**RUIDOSO-RUIDOSO DOWNS REGIONAL WWTP
JOINT USE BOARD**

**PHASE 1A – SLUDGE HANDLING AND
ULTRAVIOLET DISINFECTION
FACILITIES – 2008**

CHANGE ORDER NO. 01

February 11, 2009

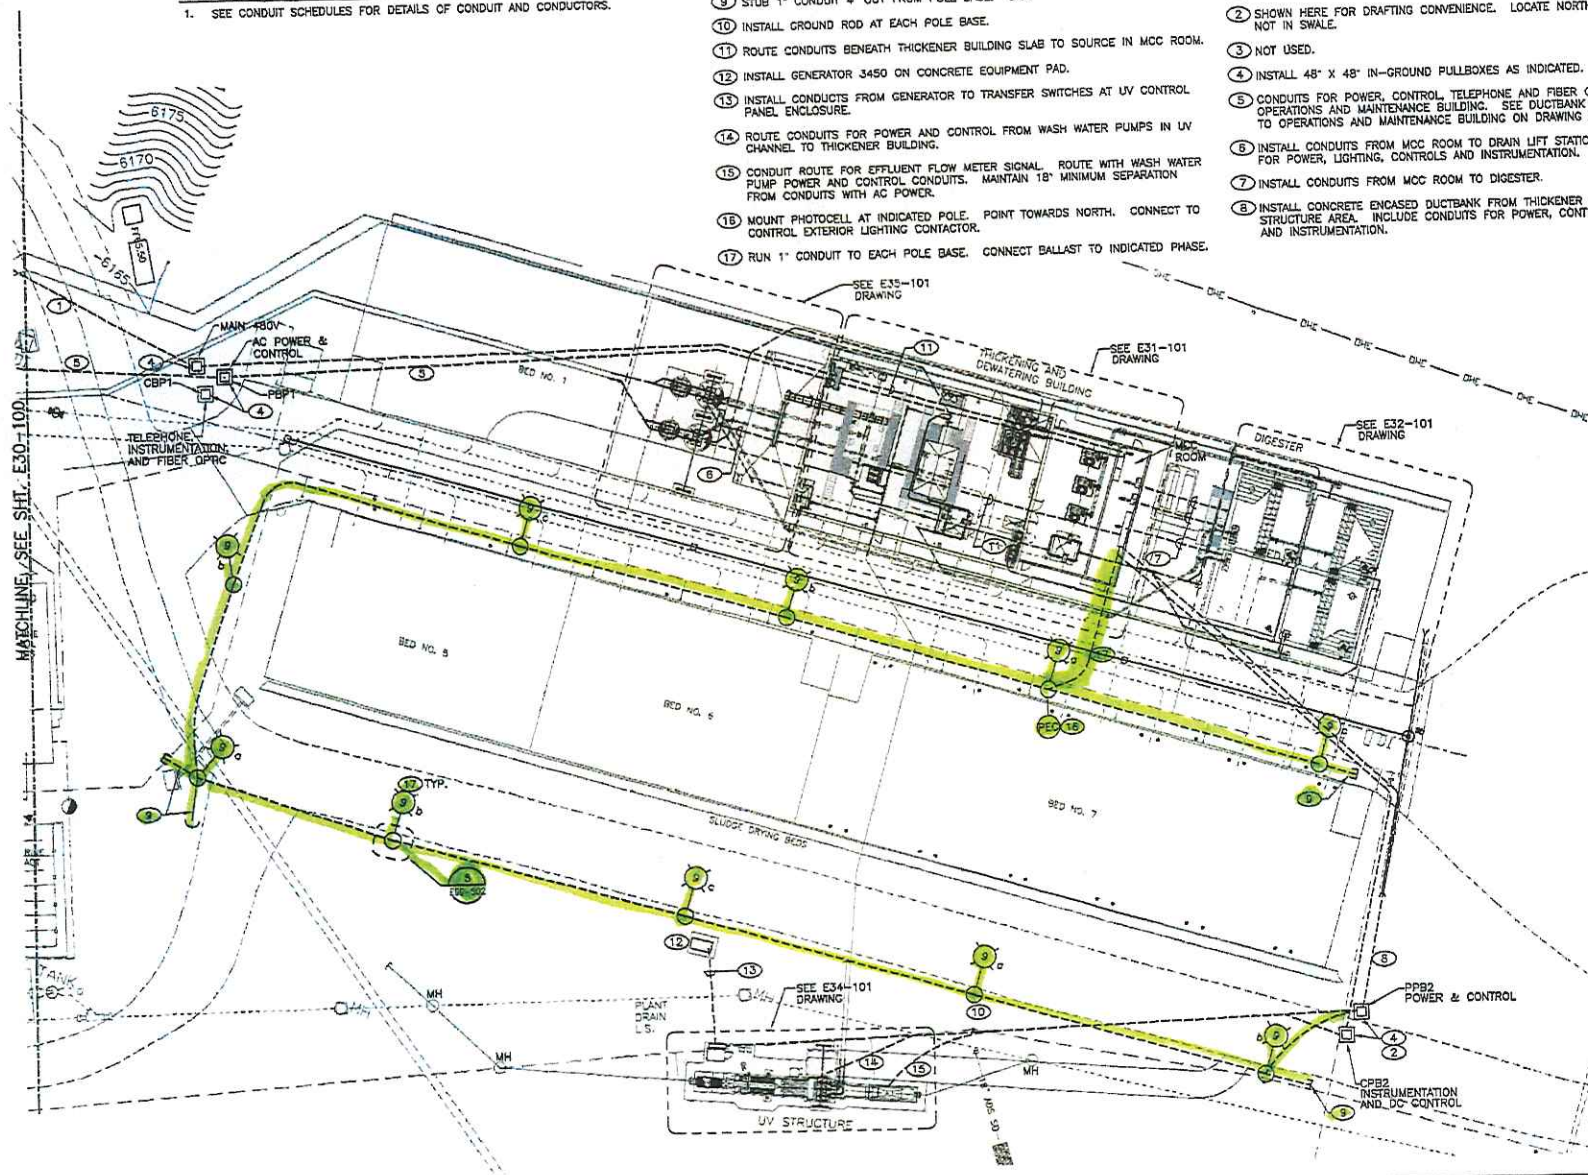
A. SCOPE AND JUSTIFICATION: The Engineer suggested to the Owner to delete the high level of yard lighting and provide minimal task lighting. This concept was accepted by Bill Morris and Cleatus Richards on December 9, 2008 construction meeting. The scope of work for the deleted yard lighting system is shown on the attached Sheet E30-101.

B. ENGINEER'S COMMENTS: The Contractor's price proposal is for a credit of -\$34,007.74 for deletion of 10 light poles and support systems shown on drawing Sheet E30-101 (attached). No additional contract time is requested by the Contractor. We find the labor and material costs reasonable for the scope of work.

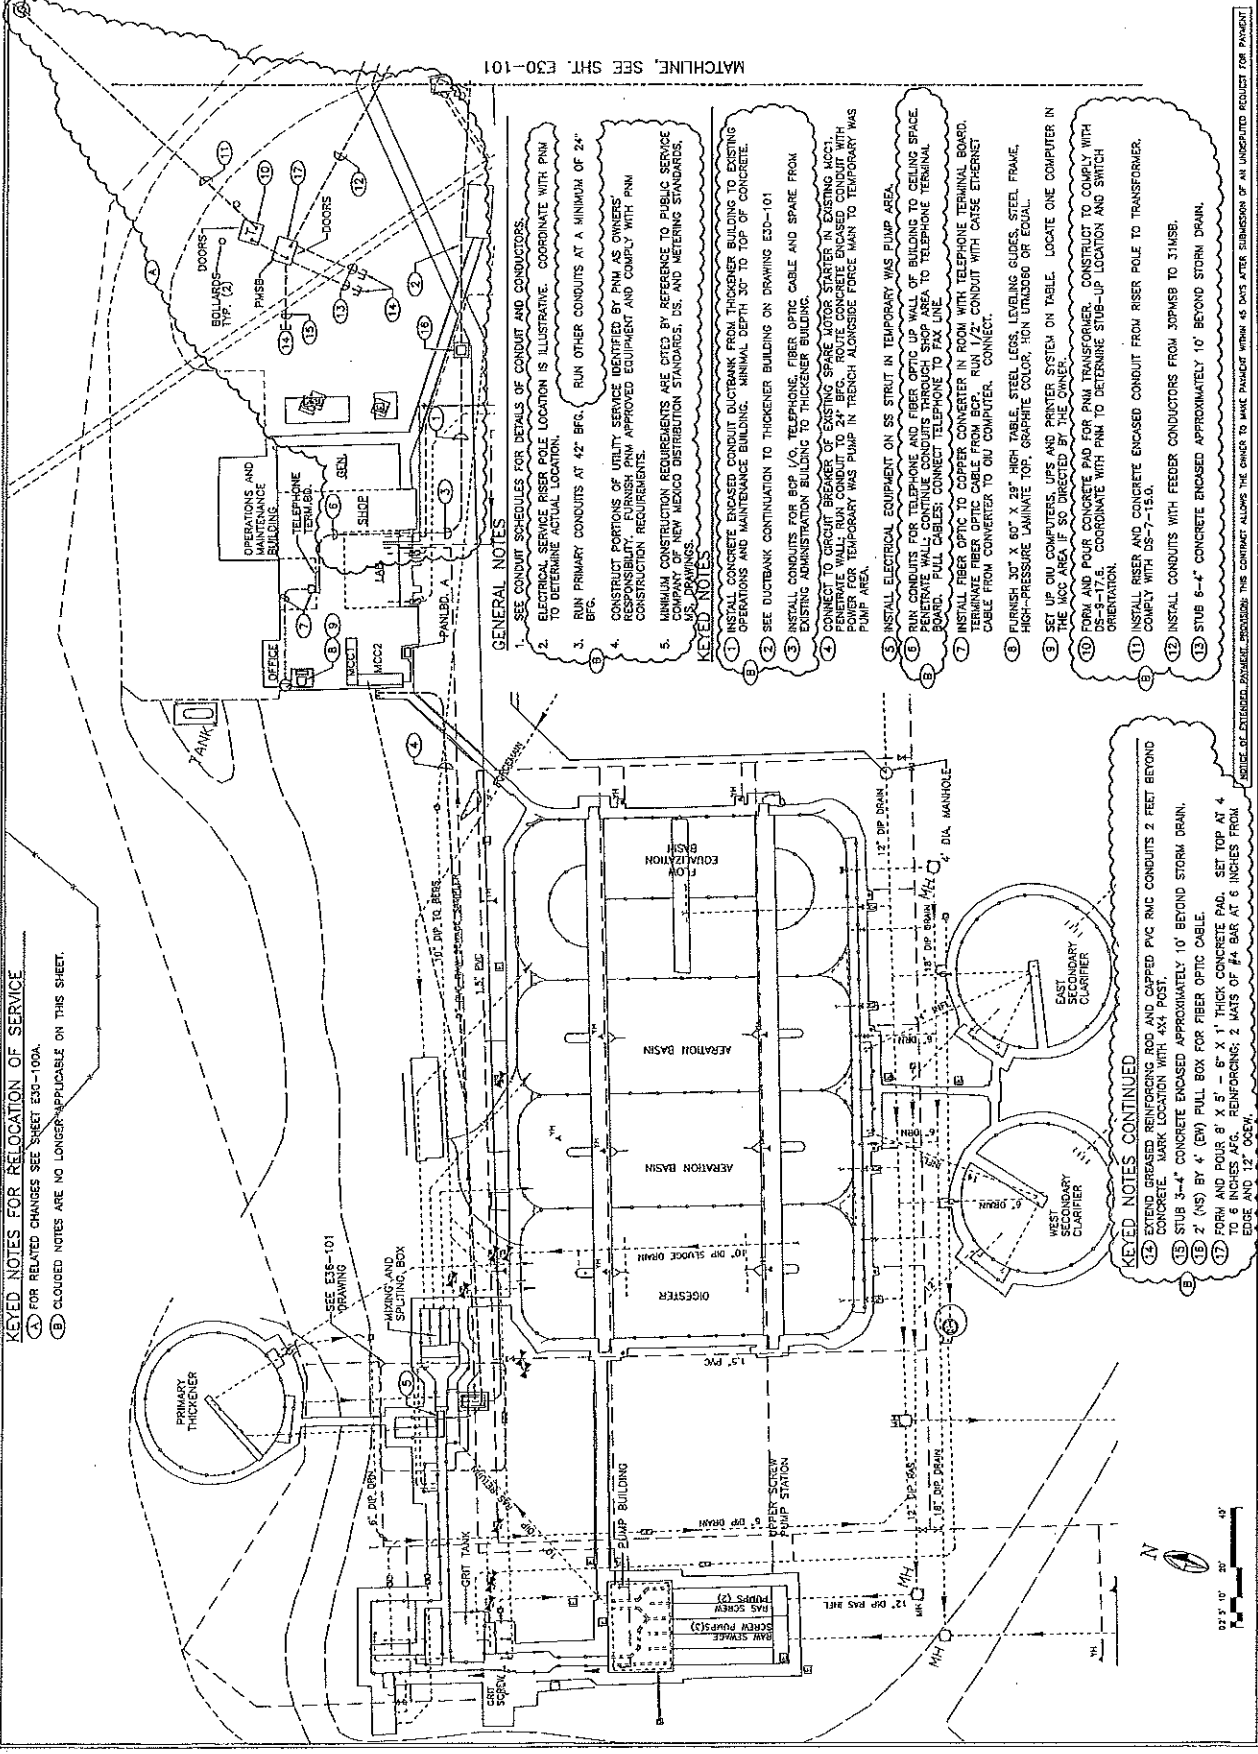
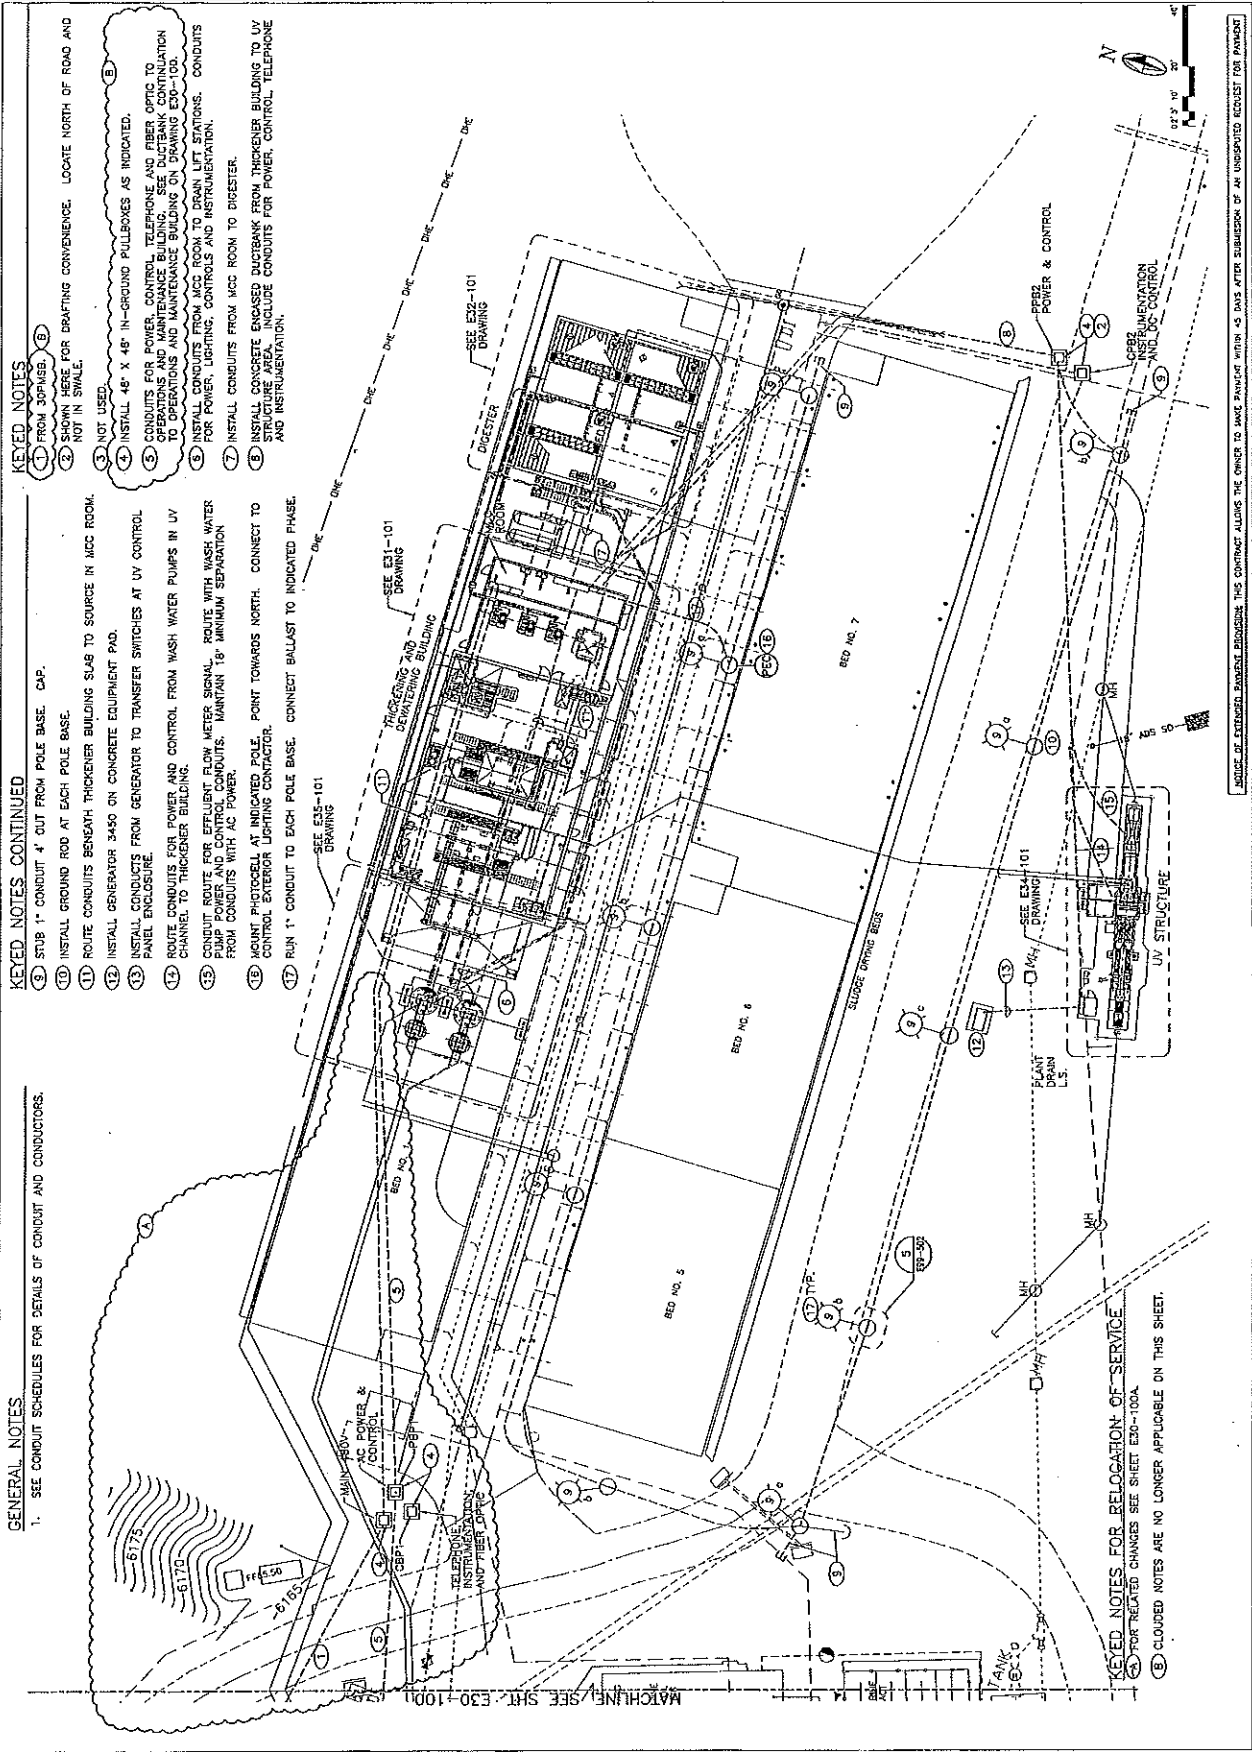
1. During the design of Phase 1A, a new primary service and new plant main switchboard, 30PMSB was shown. Knowing that Phase 1B would follow closely, it was sized for Phase 1A loads and a portion of Phase 1B loads and the switchboard was located east of the existing Administration Building, the location being chosen as convenient for both purposes.
2. During the design of Phase 1B, the decision was made to fill the area east of the existing Administration Building in order to provide parking and ADA access to the office and lab area in the new structure. Therefore, the new service will need to be moved. There are also some control conduits which are affected.

1. Move the new utility transformer and the switchboard toward the northeast, moving associated power conduits to match. This will require some changes to the grading.
2. Move control conduit runs and associated boxes northward.

1. Sheets E30-100R1 and E30-101R1 show the equipment and conduits in locations as bid and show modifications to remove all affected items from these sheets. A side effect of the relocation will be deletion of two in-ground pullboxes, at least one of which will be added to the Phase 1B design. The lengths of several conduits will change, again with some effect on Phase 1B. The amount of work performed by Otero County Electric Cooperative will be slightly less.
2. Because there is a match line in the original design, a new sheet, E30-100A, was created in order to show the relocated equipment and conduits on a single sheet. This sheet shows
 - a. New contours, requiring additional grading.
 - b. New location of the primary riser pole, primary conduit, utility transformer, switchboard 30PMSB, and affected power conduits.
 - c. New location of control conduits and boxes.

- (A) FOR RELATED CHANGES SEE SHEET E30-100A.
- (B) CLOUDED NOTES ARE NO LONGER APPLICABLE ON THIS SHEET.
